Groundwater Transfer Review Summary Form

Transfer/PA # T- 14145

Ground Water Review Form:

Application: T-14145

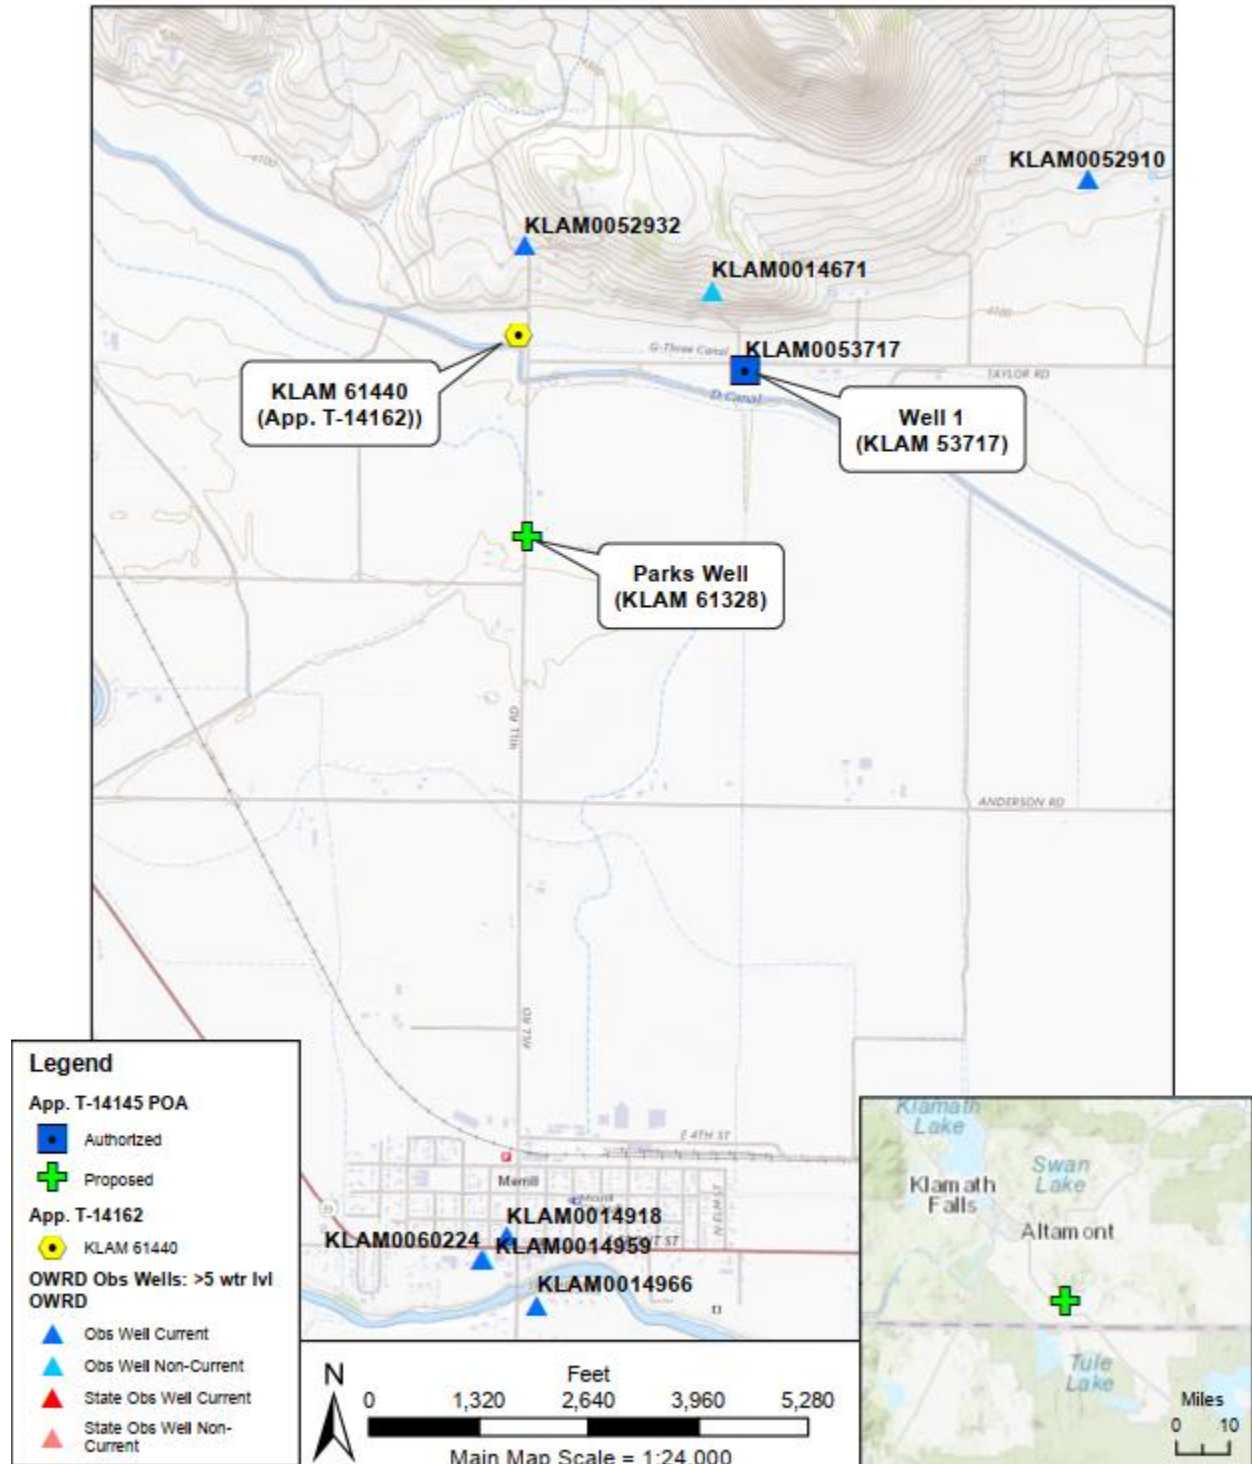
8. What conditions or other changes in the application are necessary to address any potential issues identified above: _____
9. Any additional comments: Groundwater level data from wells in the Merrill area indicate significant declines have occurred since 2001 (See attached area well hydrograph). **KLAM 53717**, authorized POA “**Well 1**”, has seen 40.25 feet of decline from an annual high of 24.38 feet below land surface (bls) in April 8, 2004 to 64.63 feet bls in March 27, 2023 (See attached hydrograph of **KLAM 53717**).

OWRD staff have collected water level measurements from **KLAM 53717** since 2004. Water level measurements indicate that **KLAM 53717** has triggered the 25 feet or more decline condition starting in 2022 when water levels dropped below 54.20 feet below land surface.

Area hydrographs indicate that groundwater levels in the vicinity are very similar to each other (within 3 feet) and exhibit the same trends. It is expected that static groundwater elevations would be very similar between FROM POA **KLAM 53717** and TO POA **KLAM 61328** and allows for a transfer of the established reference level listed on **Cert. 96331**. The reference level listed on **Cert. 96331** for **KLAM 53717** is 29.20 feet below land surface. The land surface elevation as determined by LIDAR measurement is 4,082.48 feet NAVD1988 which equates to a reference level elevation of 4,053.28 feet NAVD1988. The land surface elevation at the location of **KLAM 61328** as determined by LIDAR measurement is 4074.02 feet NAVD1988 which results in an equivalent reference level of 20.74 feet below land surface elevation.

Certificate 96331 establishes a reference static water level of 29.20 feet below land surface to which decline conditions are to be compared to. If approved, the certificate resulting from this transfer should establish 20.74 feet below land surface elevation as the reference static water level which decline conditions are compared to for KLAM 61328.

Theis Time-Distance Drawdown

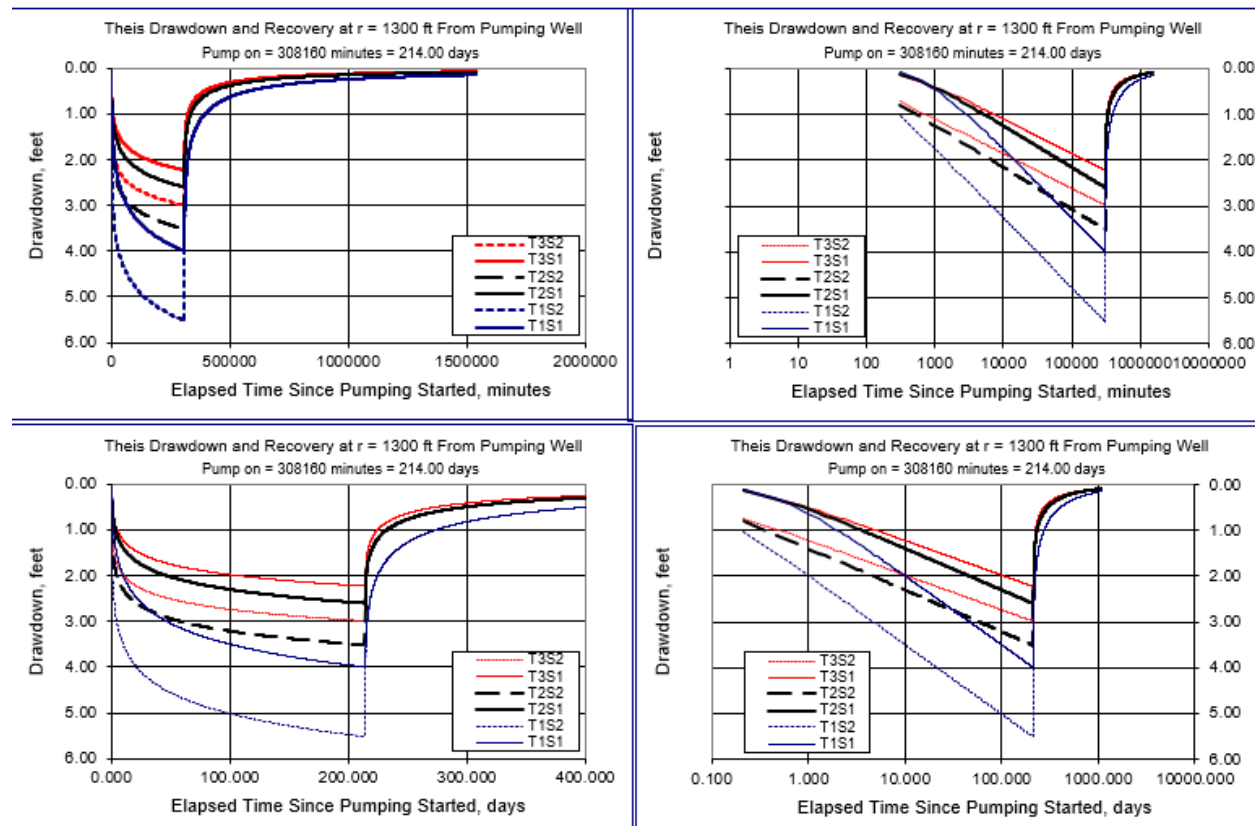
- b) If yes, would this proposed change, at its maximum allowed rate of use, likely result in another groundwater right not receiving the water to which it is legally entitled?
☐ Yes ☒ No If yes, explain: A Theis Time-Distance drawdown analysis was used to estimate the potential drawdown that would be observed in a well 1,300 feet away from the proposed POA at the maximum allowable rate (115.3 acres * 1/80 cfs/ac = 1.44 cfs) for the duration of the irrigation season (214 days). Results indicate that use from the proposed POA would likely cause less than 6 feet of drawdown over the course of the irrigation season when compared to less than 4 feet of drawdown if that use was to remain at the authorized POA (see attached Theis analysis). Due to the generally high-transmissivity and thickness of the aquifer it is unlikely that the proposed change at the maximum allowed rate of use would result in a nearby reasonably efficient well that fully penetrates the aquifer not receiving the water to which it is legally entitled to.
